**METROPOLITAN GOVERNMENT OF NASHVILLE AND DAVIDSON COUNTY**

**STAFF RECOMMENDATION**  
**1114 Lillian Street**  
**January 15, 2014**

**Application:** New construction - infill  
**District:** Lockeland Springs-East End Neighborhood Conservation Zoning Overlay  
**Council District:** 06  
**Map and Parcel Number:** 08313013600  
**Applicant:** Jeff Zeitlin, Martin Construction  
**Project Lead:** Sean Alexander, sean.alexander@nashville.gov

<p><b>Description of Project:</b> The applicant proposes to construct a new two-story house with attached garage on a narrow lot. The house will be narrower and taller than the closest historic context.</p> <p><b>Recommendation Summary:</b> Staff recommends disapproval of the application to construct a new two-story house at 1114 Lillian Street, finding the height and scale, setbacks, rhythm of spacing, windows and doors, materials, proportion and rhythm of openings, appurtenances and utilities to be incompatible with the surrounding historic context and design guidelines II.B. 1, 2, 3, 4, 7 and 9.</p>	<p><b>Attachments</b> <b>A:</b> Photographs <b>B:</b> Site Plan <b>C:</b> Elevations</p>
---	--

GRADING SITE PLAN  
 1114 LILLIAN STREET  
 A HORIZONTAL PROPERTY REGIME  
 WITH PRIVATE ELEMENTS

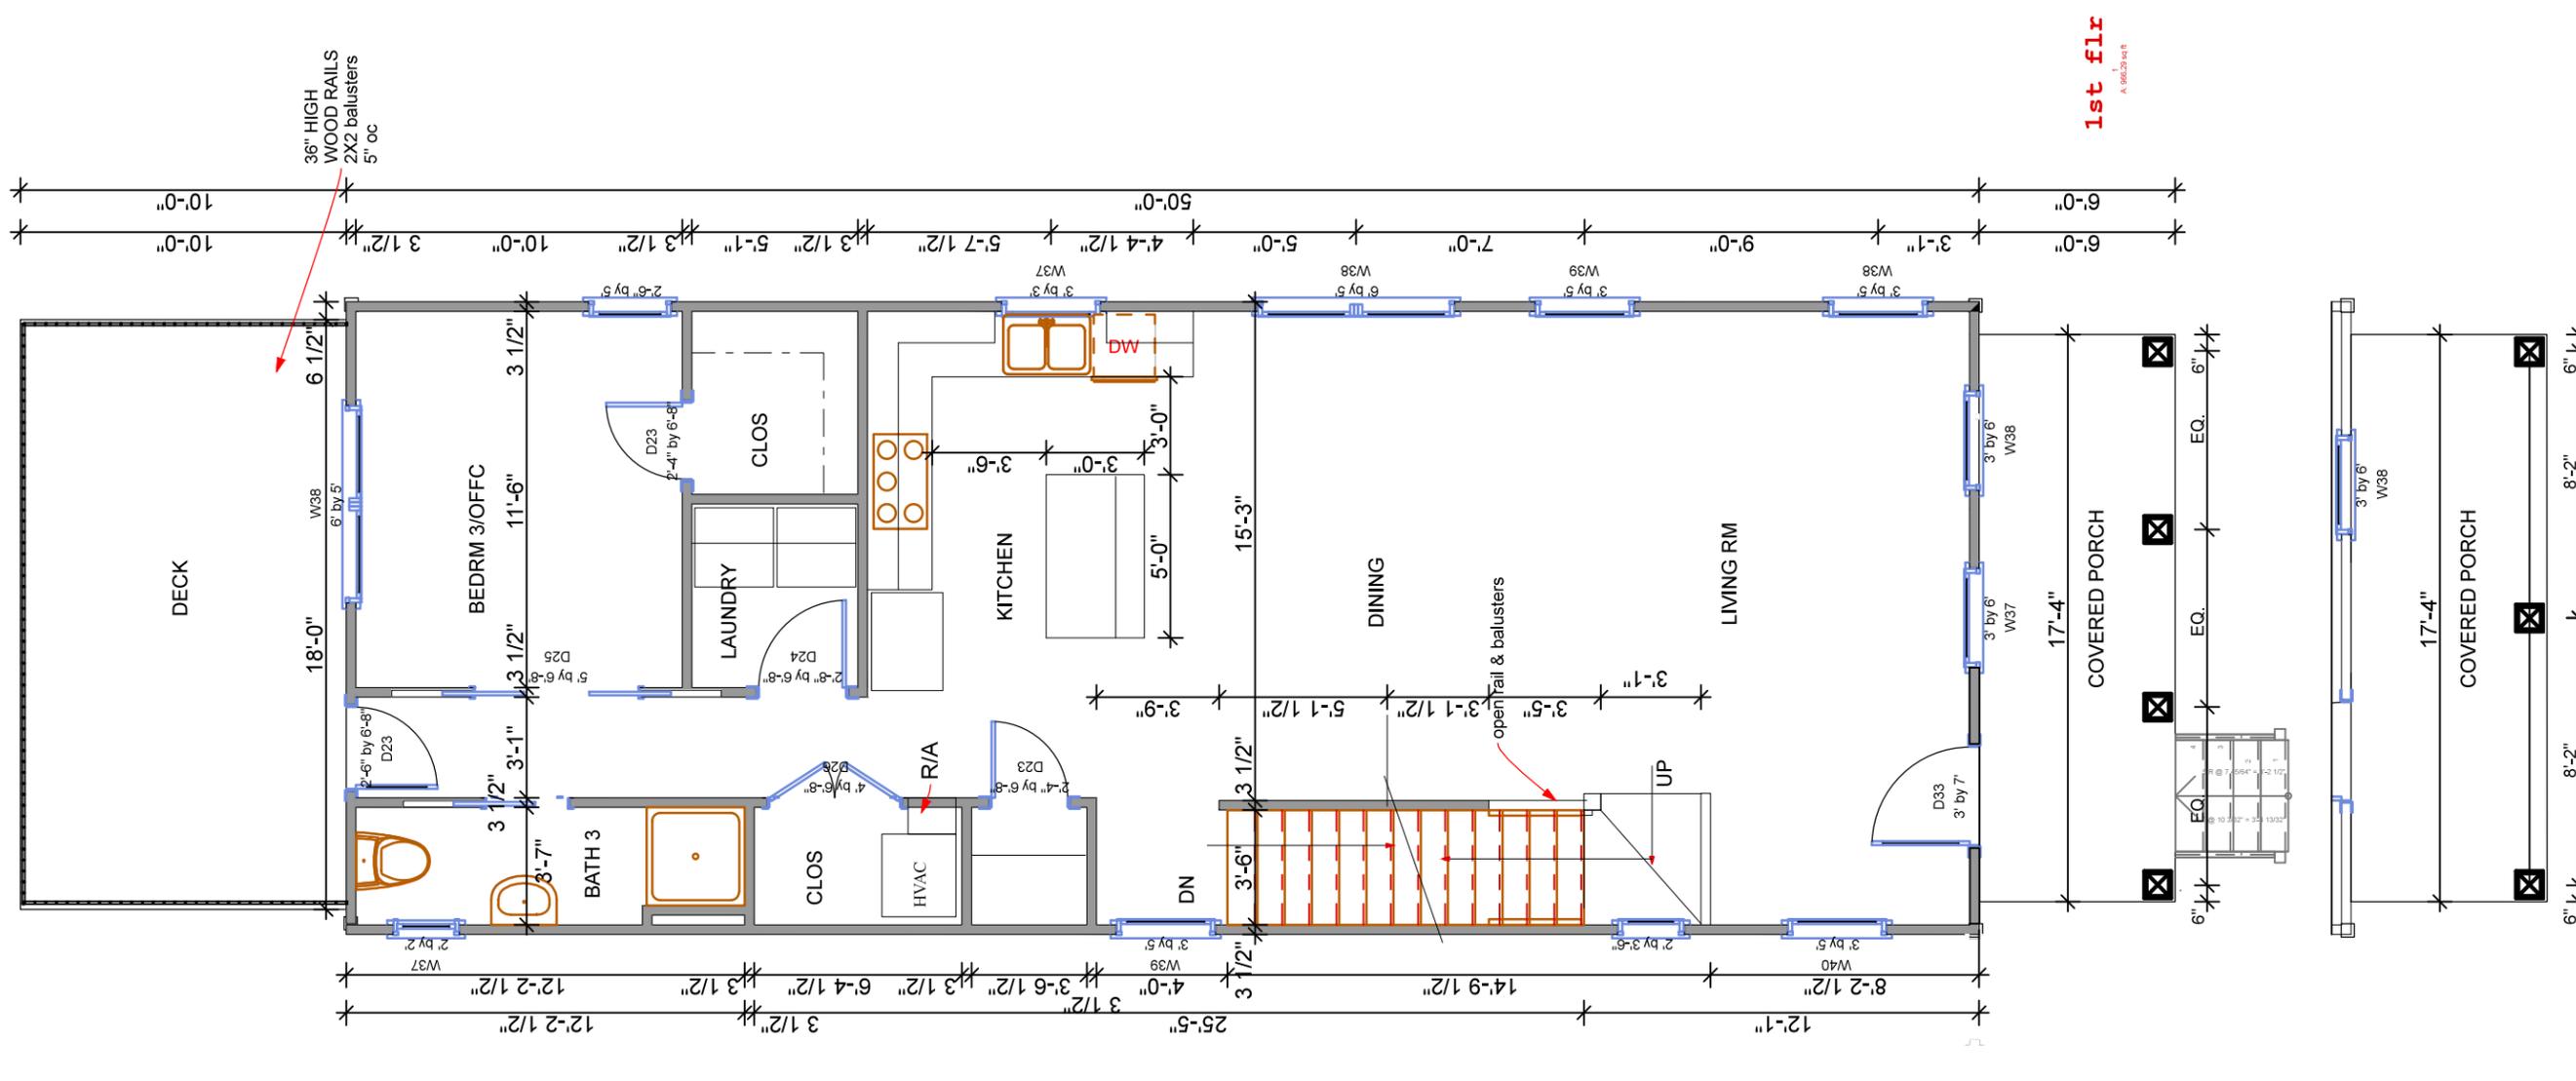
The front of the building will be located with the front edge in line with adjacent structures, between eighteen and twenty feet (18' - 20') from the street, which is an appropriate setback. The building's side setbacks will be approximately six feet, six inches (6'-6") on each side. Although this meets bulk zoning requirements the width and resulting side setbacks do not match the rhythm of the street, as seen in the areas of historic context.

The location of the HVAC and other utilities was not indicated on the drawings. The HVAC should be located on the rear façade or on a side façade beyond the midpoint of the house in order to meet section II.B.9.

Basement Plan  
 1/4" = 1'-0"

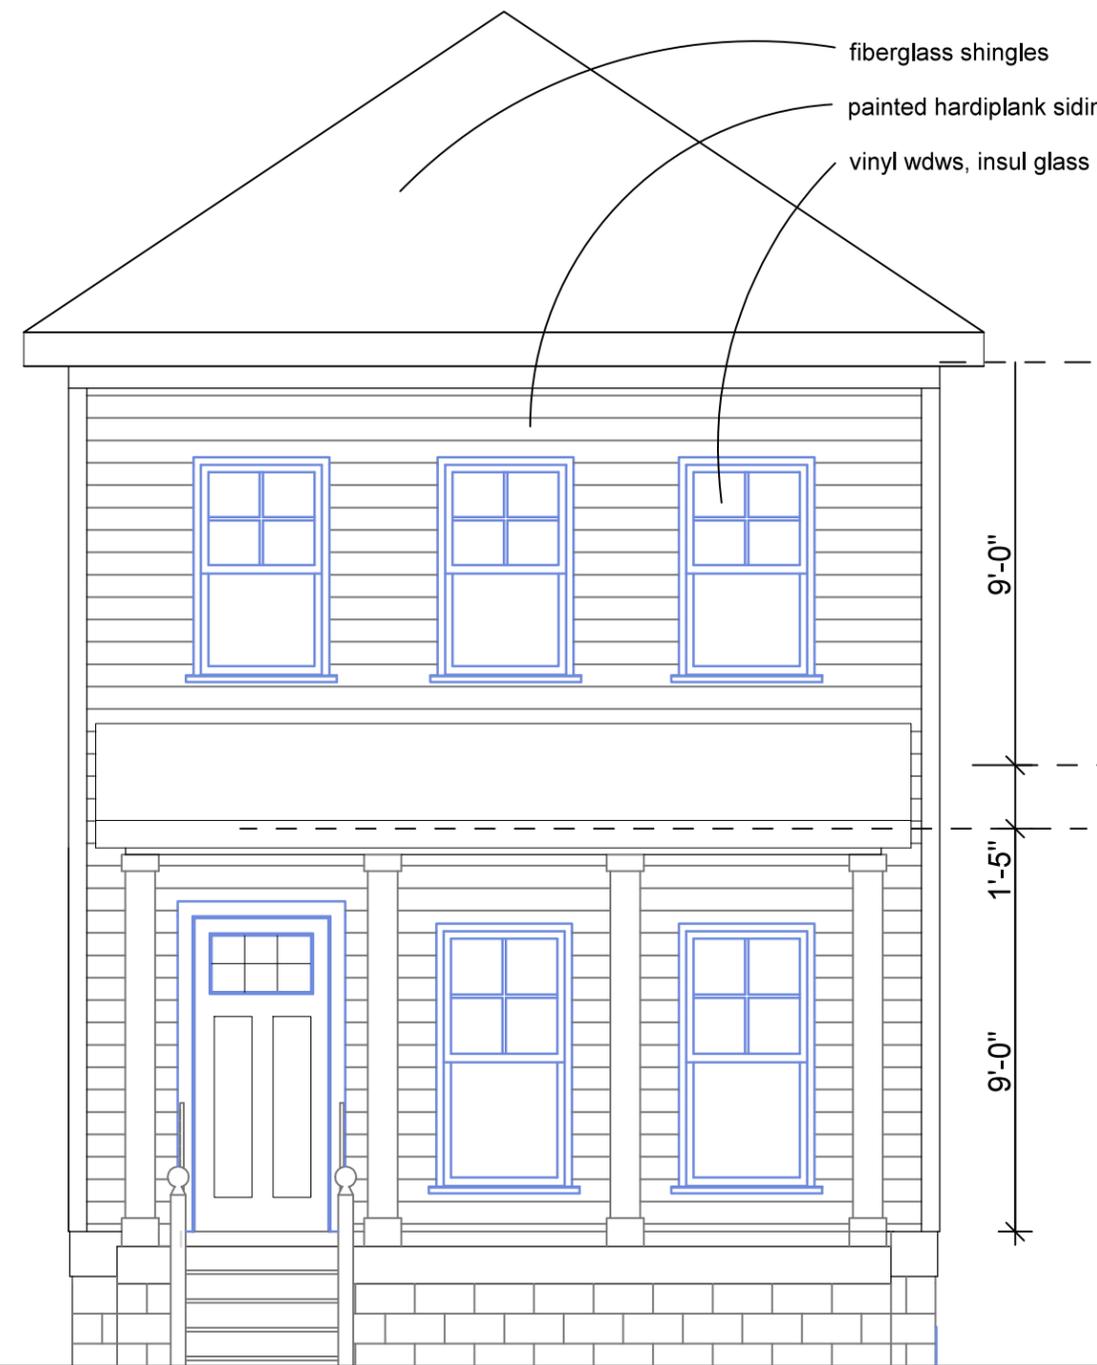
The new building would have a two-car garage in the basement, accessed by a driveway from the rear alley. The Commission has approved rear-accessed garages in basements when they are in the typical location of historic outbuildings. Staff finds that the project meets section II.B.8 of the design guidelines.

Firstly, the current proposal would have a five hundred square foot (500 sf) garage in the basement level of the house. Staff has recommended that the garage be separated from the house and placed at the rear of the lot. The exposed basement area could then be more efficiently used as living space, reducing the amount of living space that would need to be in the upperstory. This would also be more appropriate because historically garages would have been detached and located at the rear of a lot.

FRONT ELEVATIONS

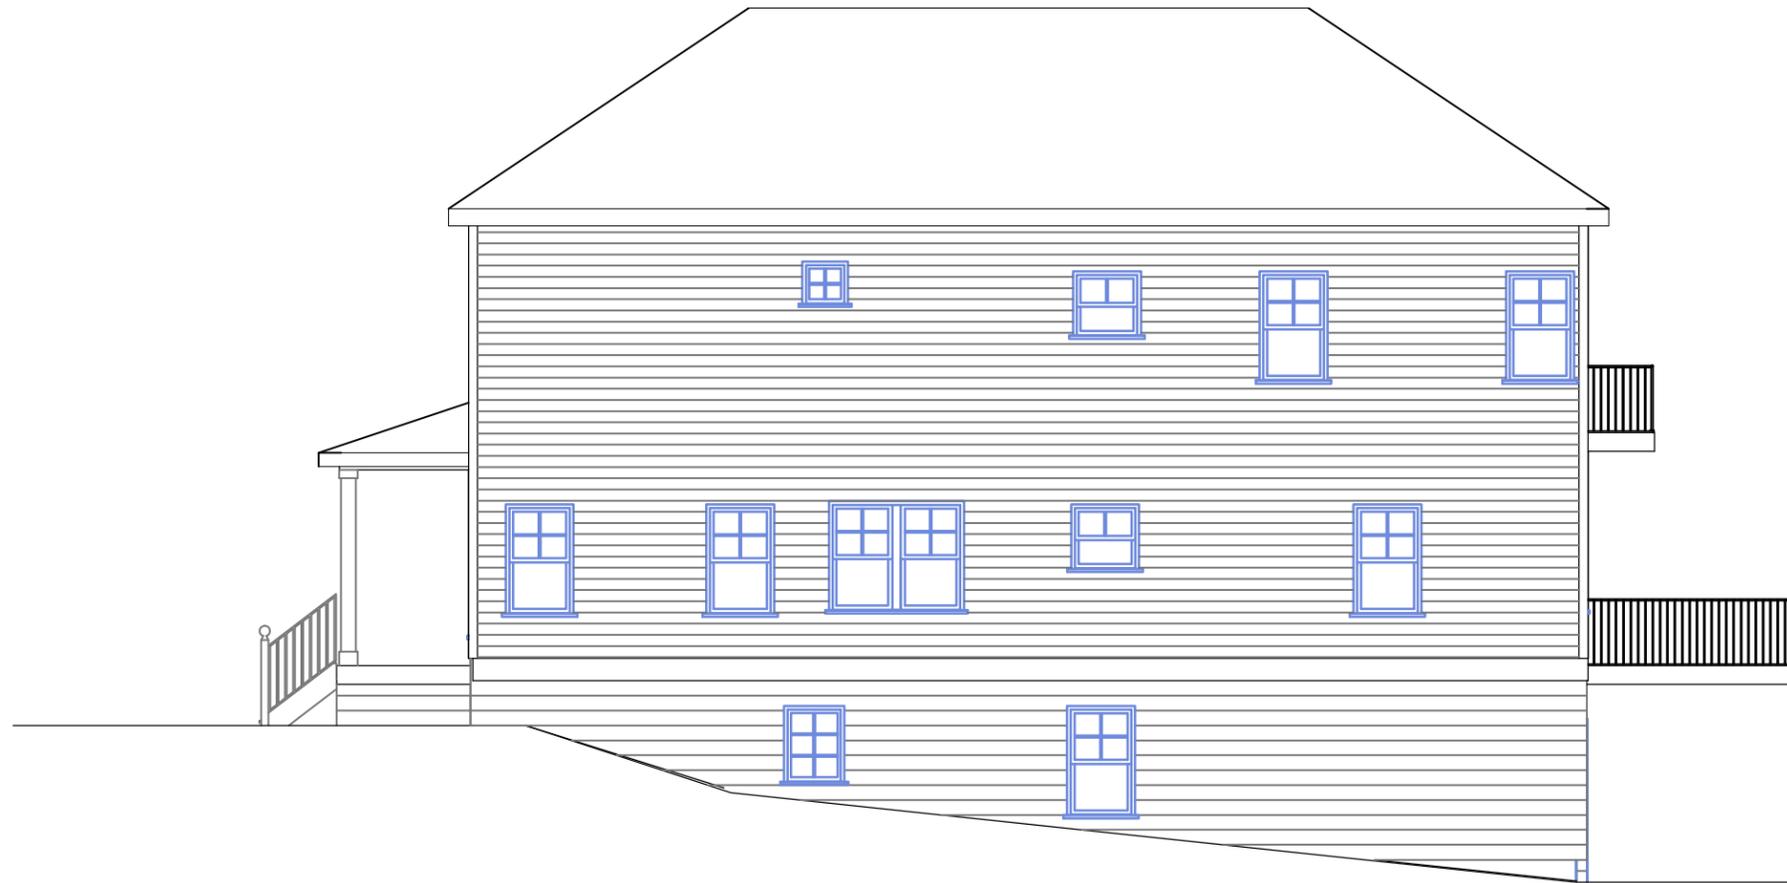
The new building will be two-stories tall with the peak of the roof at thirty-two feet (32') and eaves at twenty-two feet (22') above grade at the front. By comparison, the existing houses on Lillian Street range between thirteen feet (13') and twenty feet (20'). There will be two feet (2') of foundation exposed and a one foot (1') water-table band between the foundation and the finished floor level. Due to a drop in grade, the structure will gain an additional story in the basement level at the rear. The plans show the basement-level as having a bedroom, a bathroom, and a two-car garage.

The new building will be nineteen feet, four inches (19'4") wide; whereas homes on Lillian Street are generally between twenty-four and thirty-two feet (24' - 32') wide.

Staff finds that the height and scale of the proposed two story house would not be compatible with surrounding buildings and would not meet guidelines II.B.1 and II.B.2.

The front elevation will have two evenly-spaced bays on each story, which is compatible with the proportion and rhythm of openings on historic houses. The windows on the side elevations would be more irregular in their proportions and rhythm of placement. Additionally, both side elevations would have incompatibly large expanses of wall space without any openings. Staff finds the project's proportion and rhythm of openings would not meet guideline II.B.7.
